Proposal for changes to document GRSG/2020/14

Consolidated Resolution R.E.3

Submitted by the experts of OICA

“2.8.3.1. *“Approach angle”* – see Standard ISO 612:1978 term No. 6.10.

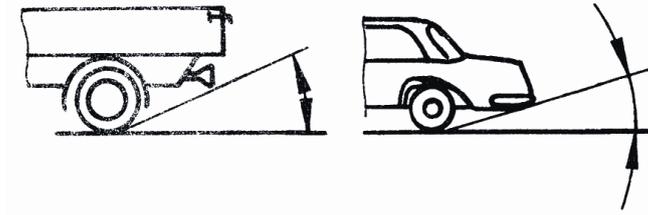
Proposed paragraphs 2.8.3.1., 2.8.3.2. and 2.8.3.3., amend to read (keep the reference to the year)

3. Paragraphs 2.8.3.1., 2.8.3.2., 2.8.3.3.: the references to the ISO standards should remain with the information on the revision since this makes a stable reference as needed in a reference document like RE3. It is indeed important that the UN regulations keep some autonomy versus the ISO standards, and that the regulators at UNECE have a visibility on the standards they are referring to.
